**LETTER TO SIGNATORIES, INVITED SIGNATORIES, AND CONCURRING PARTIES  
REGARDING THE 2011 PROGRAMMATIC AGREEMENT FOR THE MILITARY RELOCATION  
TO GUAM AND THE COMMONWEALTH OF THE NORTHERN MARIANA ISLANDS**

Subject: OBJECTION TO ACTIONS CARRIED OUT IN THE IMPLEMENTATION OF THE PROGRAMMATIC AGREEMENT PURSUANT STIPULATION XIII – RESOLVING OBJECTIONS

Memorandum

Subject: Objections Regarding the following:  
Stipulation IV. Identification and Evaluation of Historic Properties  
Stipulation V. Assessment and Resolutions of Adverse Effect  
Stipulation VI. General Mitigation Measures  
Of the 2011 PA For the Live-Fire Training Ranges, the Main Cantonment, South Andersen and the Water Well Development, Design and Construction areas.

**Attachment 1**

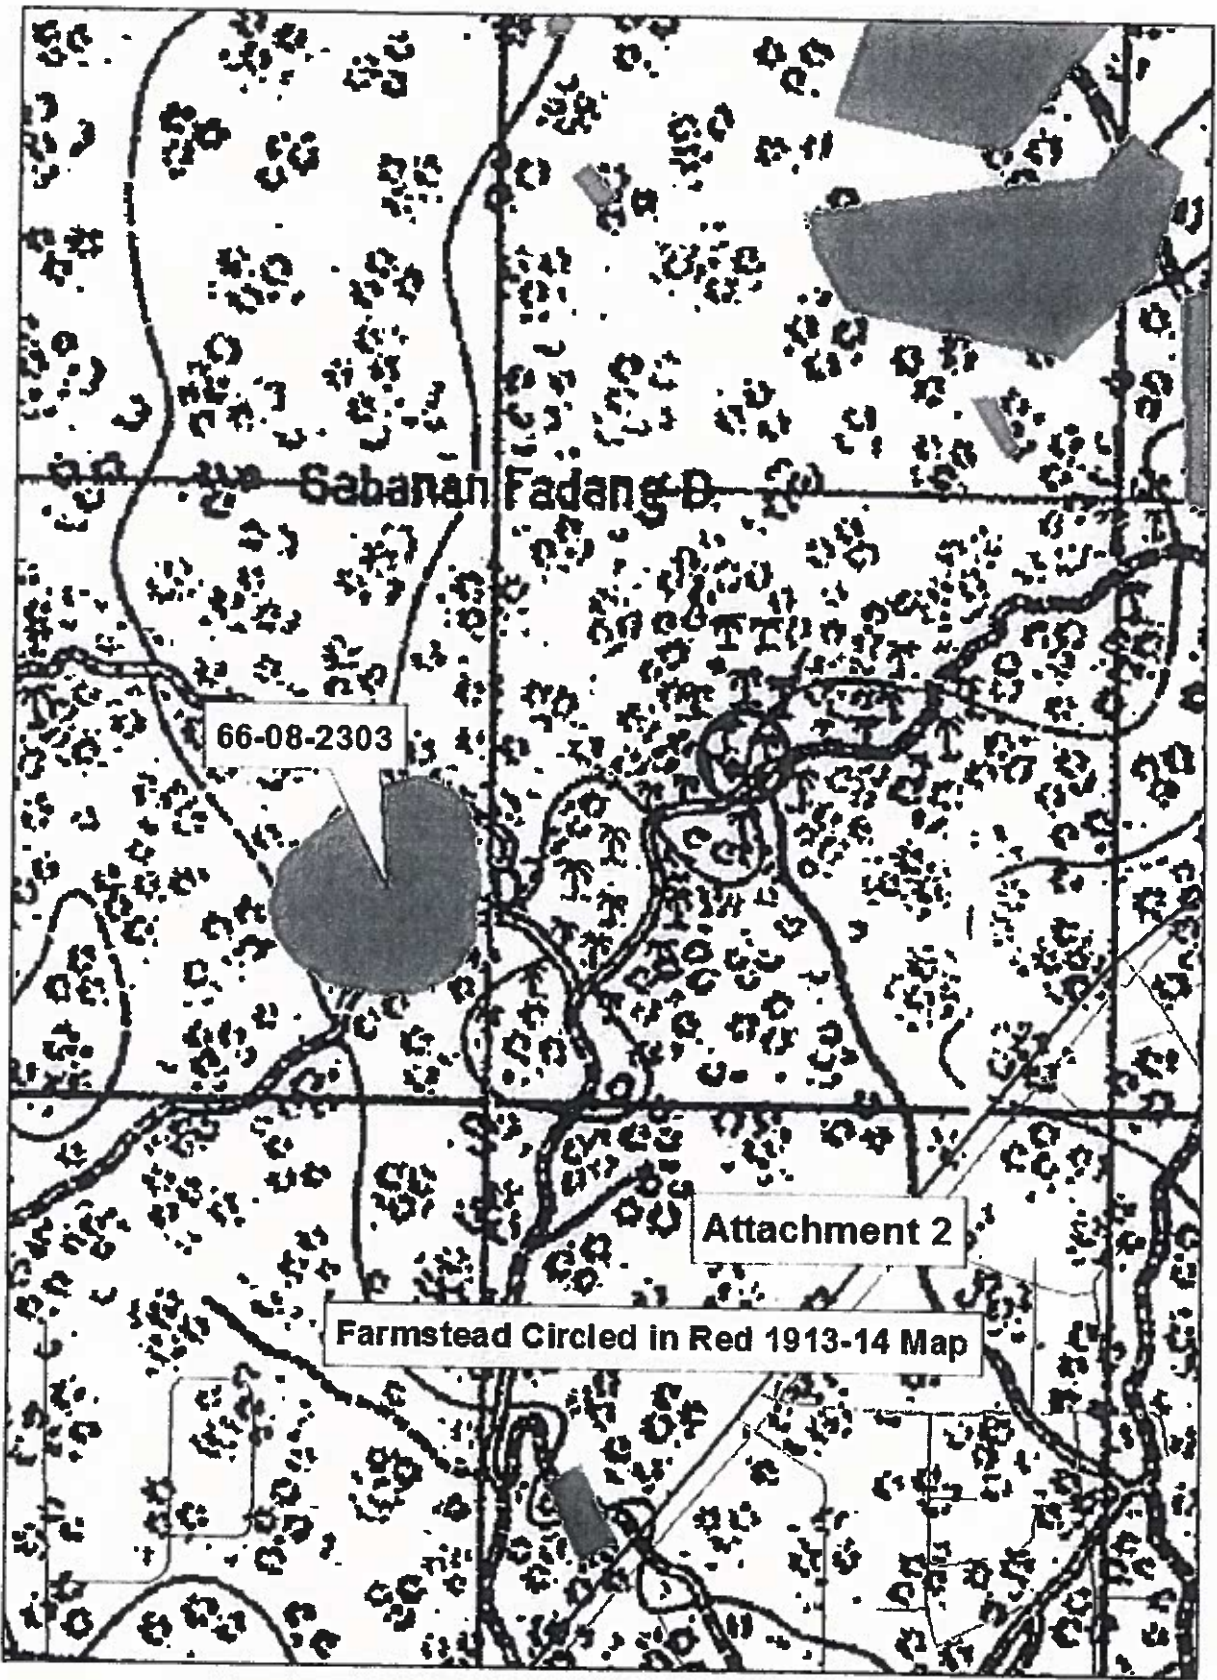
In reviewing the Welch 2010 report, and the other surveys listed in the PA Memo J-001B, the actual survey area does not cover the entire APE listed in Figure 1. The archival survey may have sufficed for the 2011 APE with its minimum impact, but this is not sufficient for the 2014 APE presented in the J-001B PA Memo. Welch's 2010 report also indicates that "field team was **not able to cover two areas** during the time allotted for the survey" (143, Vol.I), however, he **does** not indicate where these areas are located and the size of these areas. This is also compounded by Hiro Kurashina's survey with **transects varying between 90 and 180 feet**. We have marked a map Attachment 1, indicating the areas not previously surveyed during the 2010 report that need to be surveyed by boots on the ground. These areas are colored in black and marked with + symbols. The survey should also include systematic subsurface testing. The testing may provide more information and possibly expand the boundaries of sites 66-08-2303 and 66-08-2302 since the un-surveyed areas about these sites.

In reviewing the historical maps of the APE, we identified a farm site not located during Welch’s 2010 survey that survived for 40 years on the historical maps. This site appears on three historical maps, the 1913-14, the 1944 and the 1954 maps circled in red (Attachments 2, 3, and 4). We find no discussion of this site in the Welch’s 2010 report in the background research, or why it wasn’t located on the landscape. The site being historical in nature should be easily identifiable due to its age and associated trash dumps. This site could also be a part of the *Magua* Coconut Plantation.

Farmstead Circled in Red 1944 Map

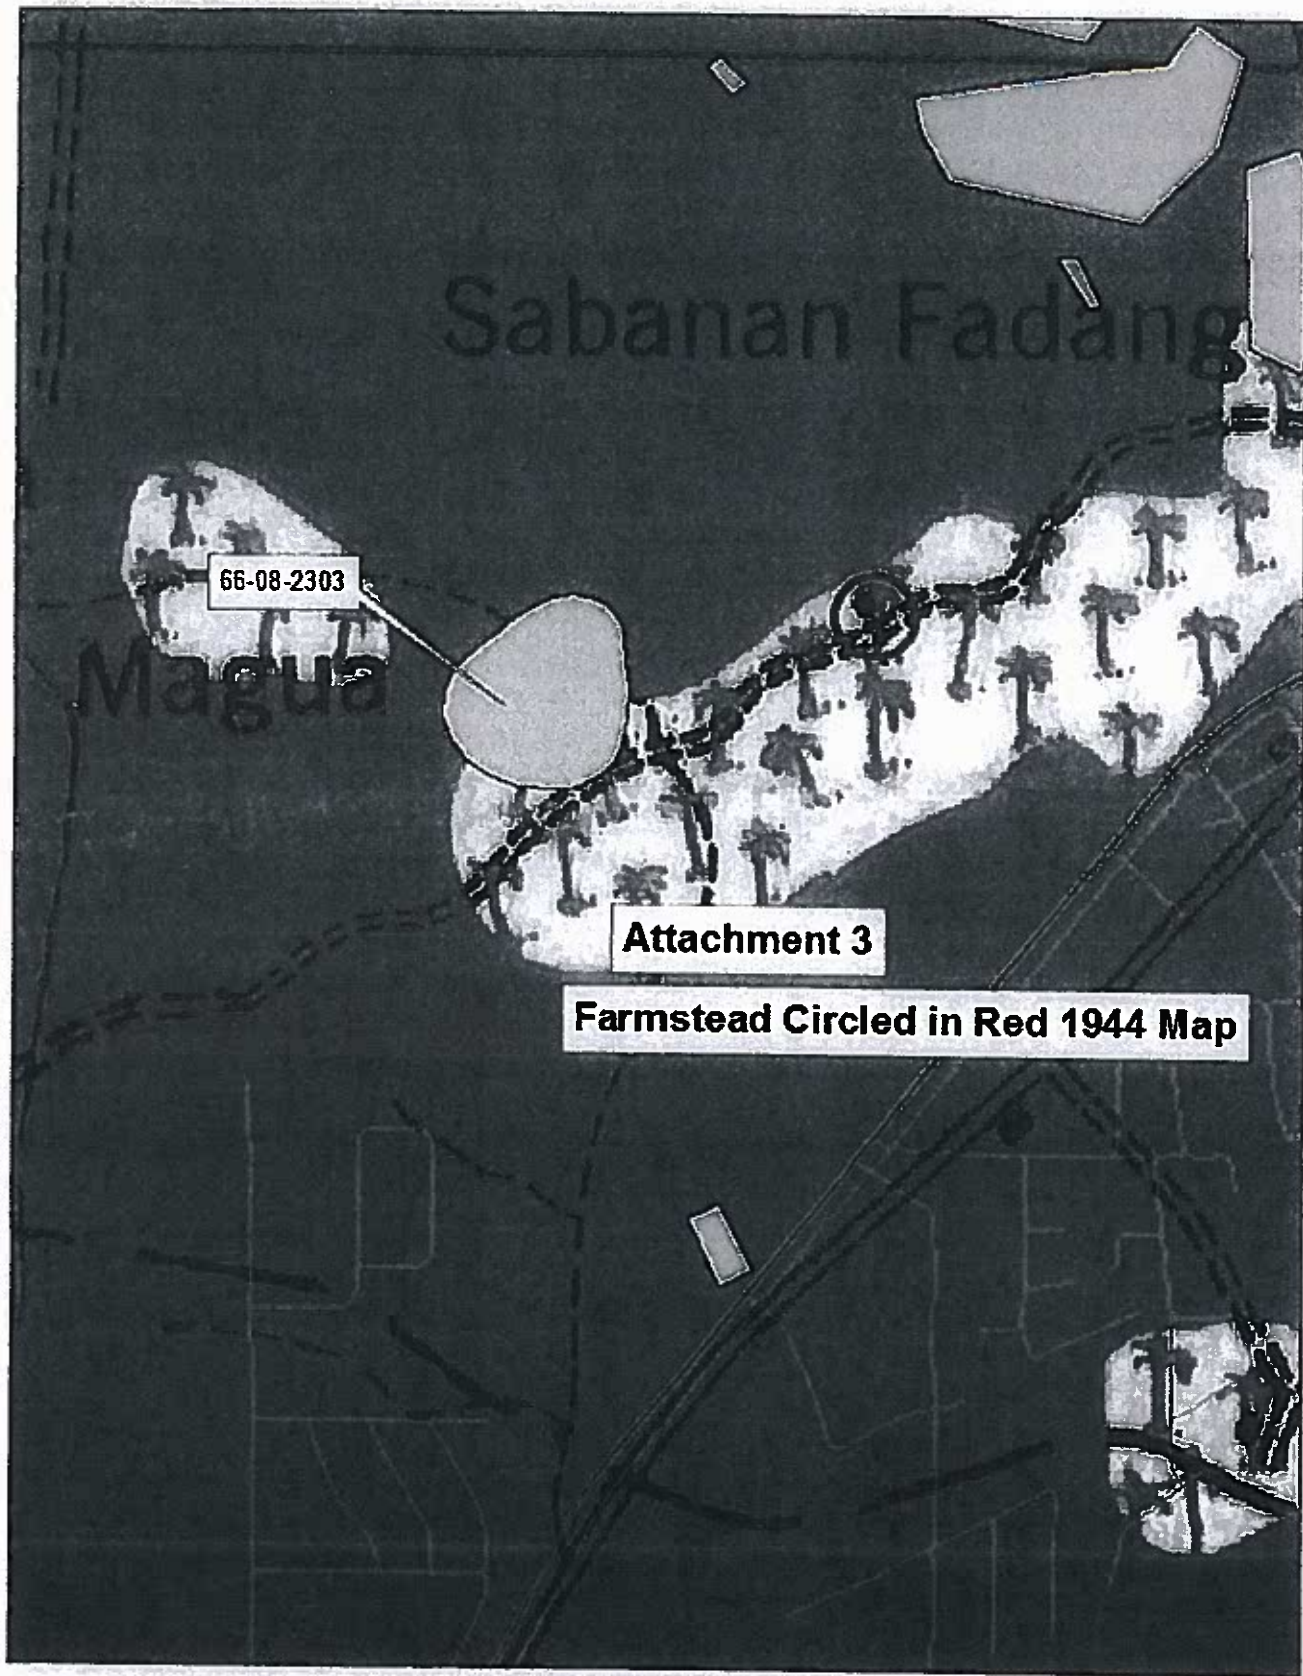
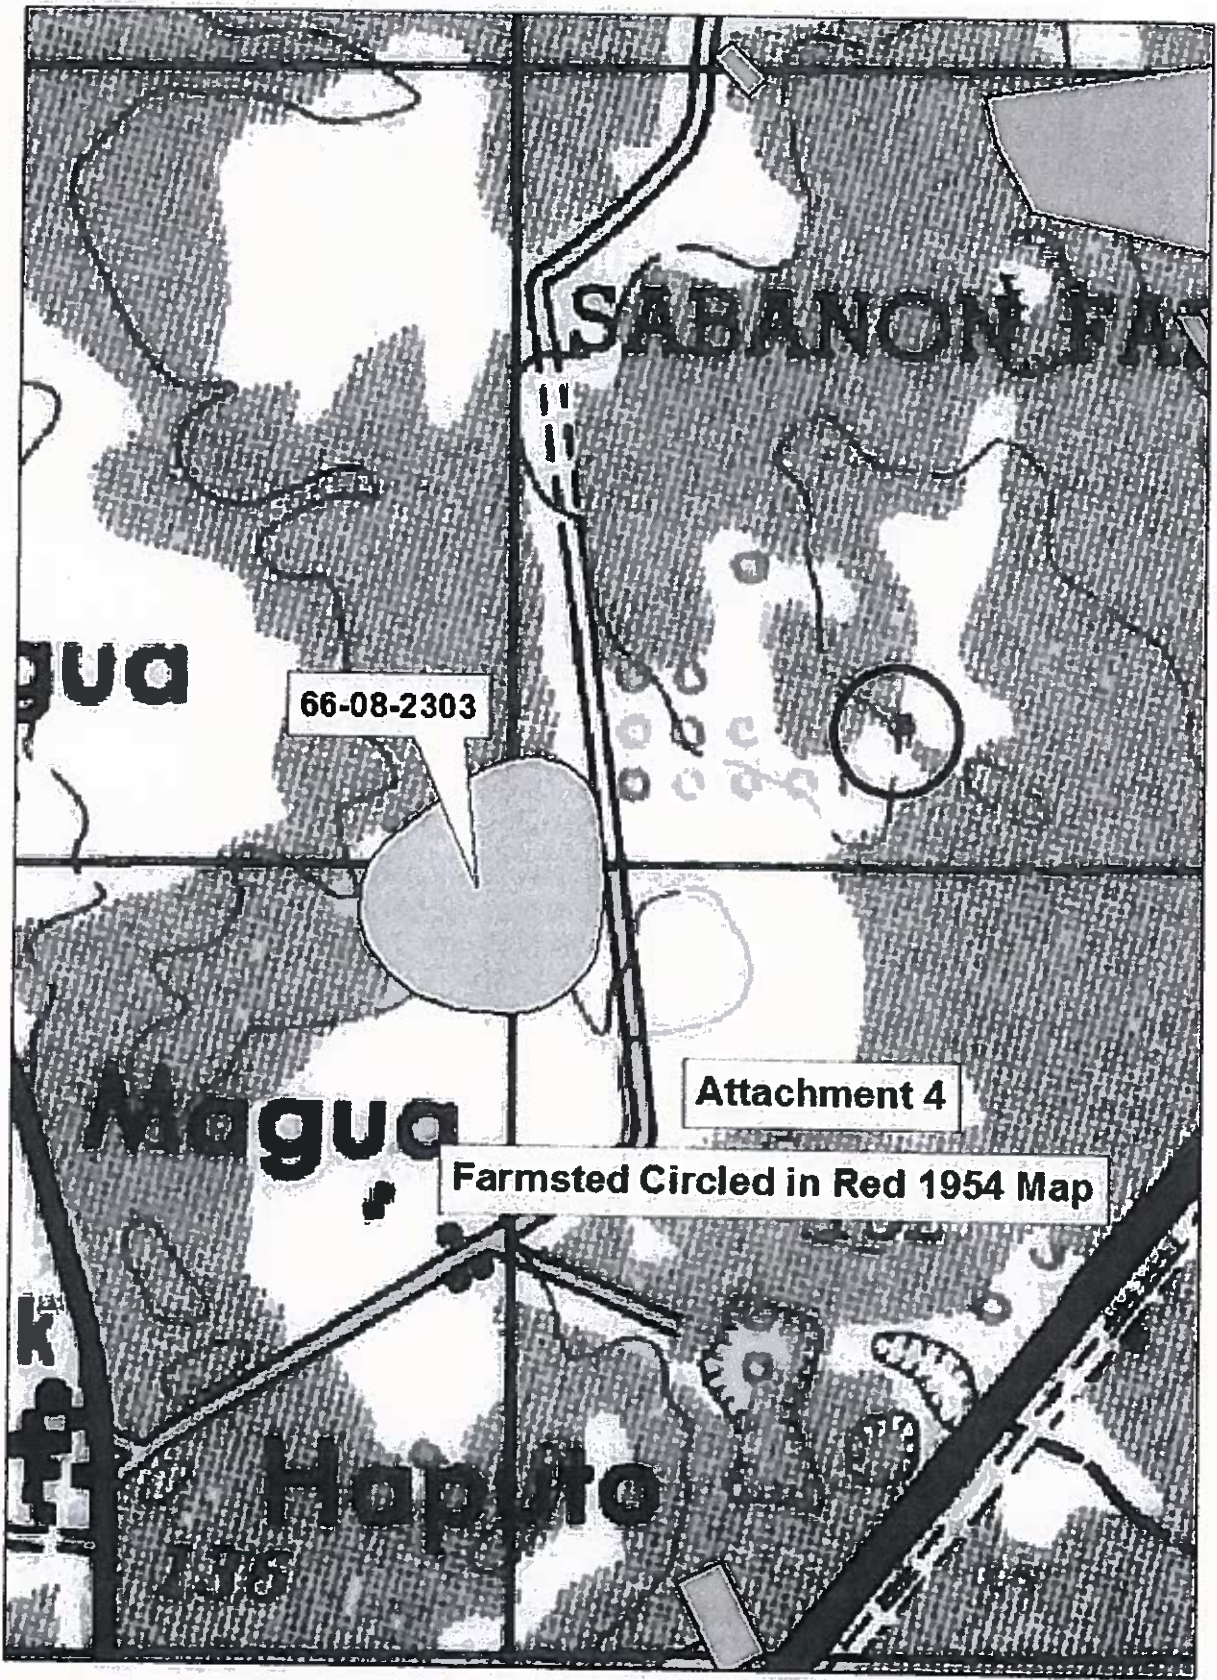
- b. In reviewing the Main Cantonment area during the SEIS, I noticed that *lâncho* were not a big part of the historical or archaeological focus. One farm, in particular stuck out on the 1913-14 map and again showed up on the 1944 map. I brought this *lâncho* to the attention of the DoN and they commented that the archaeologist must not have found anything in their 2007 survey. My response was that this period was undervalued as part of the history of the area on Feb 4, 2015 we visited the area. Within 10 minutes of entering the jungle, I was able to locate the site. A large concrete cistern approximately 12 x 12 x 4 ft stood out on the landscape. Several push piles were located in the surrounding the areas possibly from the 1950s. A patch of *pupulu* approximately 12 x 12 ft was located west of the cistern indicating evidence of horticultural practices within close proximity to the ranch. It is my belief that no survey was ever conducted in this area as is it would be almost impossible to miss such a site even in a pedestrian survey conducted at 15 meter intervals.

# Dededo-Ritidian Roads

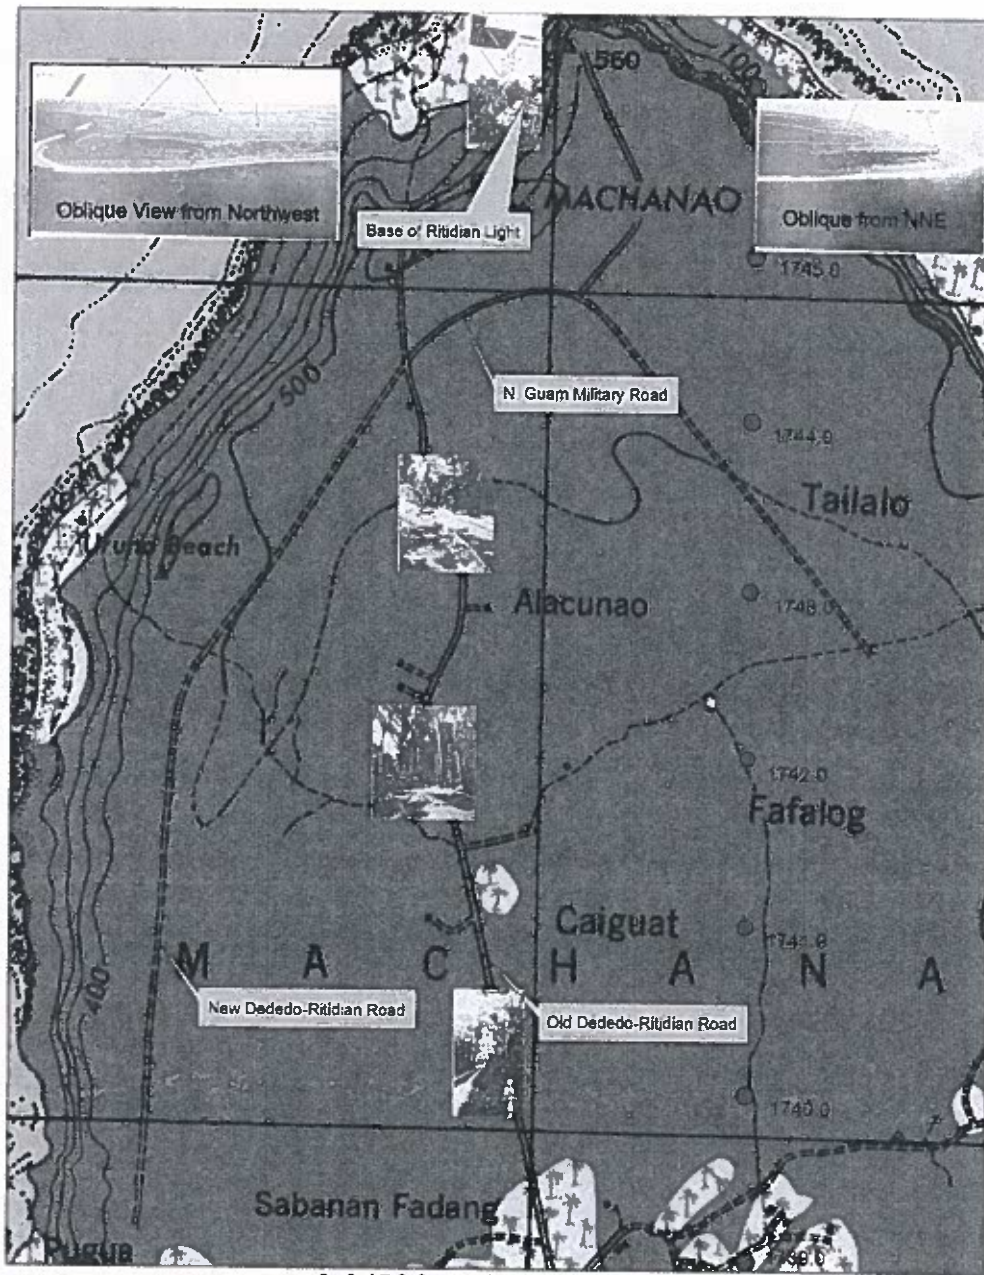
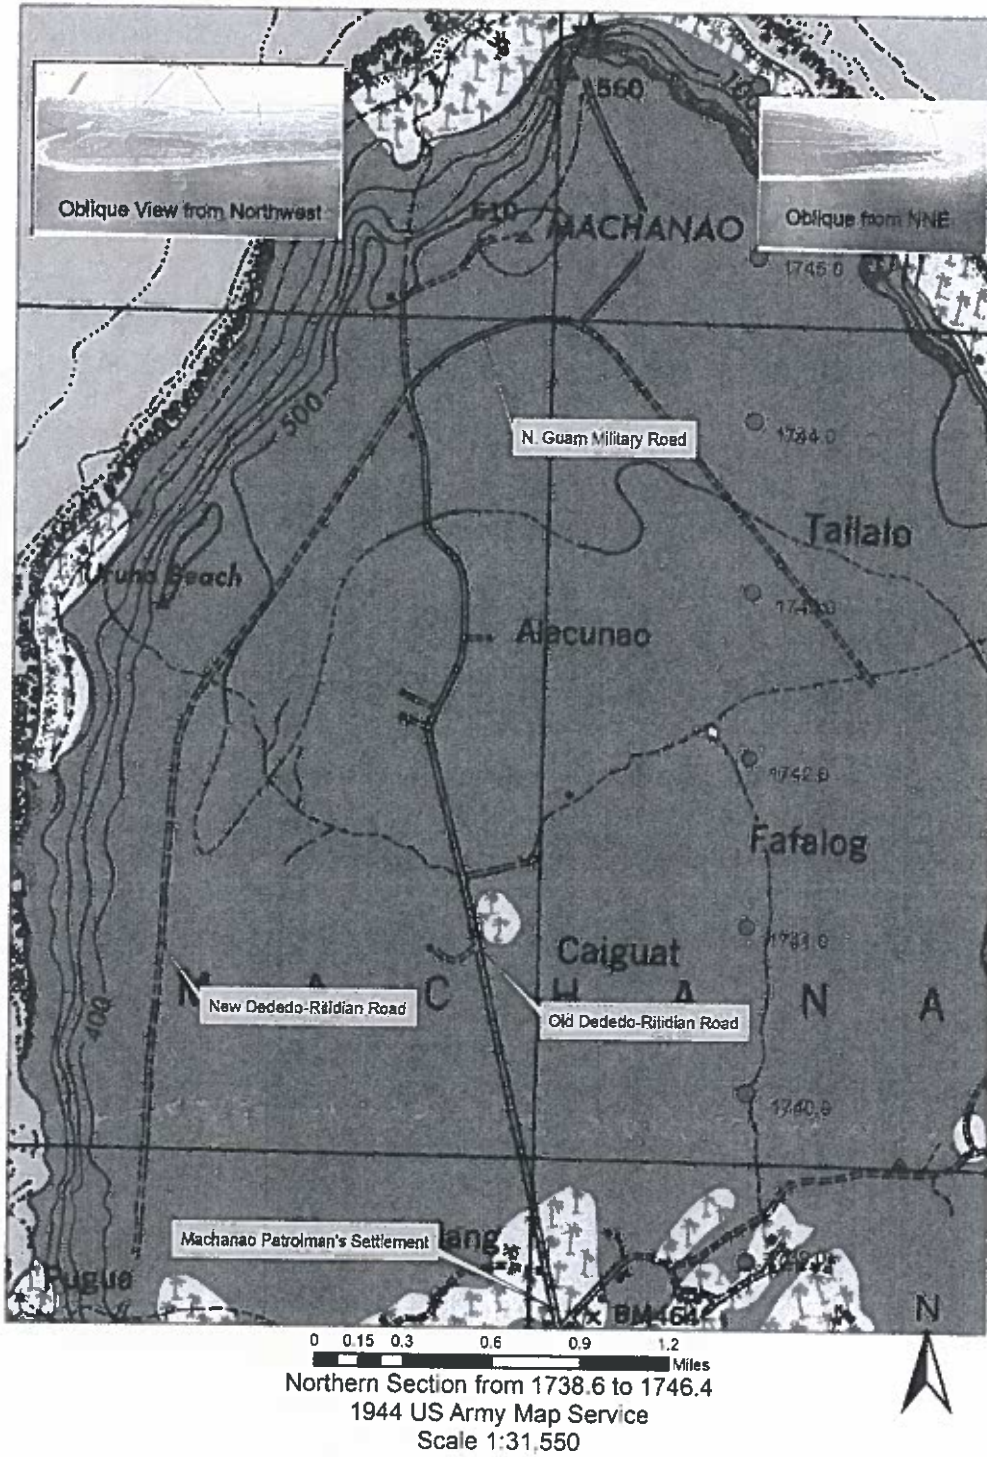
- d. In reviewing the LFTRC's APE in the SEIS we noticed that the roads in the area and other structures indicated on the historic maps were not considered as historic properties. Therefore, we requested that further studies be conducted. The DoN produced the Old Ritidian Road document (Attach. 7) to supplement the history of the area. This documentation resolved some inquiries, but raised questions concerning the existence of other historic properties in the area. A portion of the Old Ritidian Road runs through the LFTRC, and the supplemental history taken from ONI-99 verbatim mentions several structures; Machanao patrolman's quarters and settlement, Ritidian Lighthouse, “Machanao hamlet.” There is no mention of these structures in the previous reporting and may very well be within the APE of the LFTRC. Conducting pedestrian surveys in areas of low visibility, due to thick jungle or heavy dead foliage makes it hard to believe these sites would ever be found using pedestrian survey methodology. The background on Machanao patrolman's house and settlement, which may be the hamlet is basically non-existent as is that of Machanao Mountain.
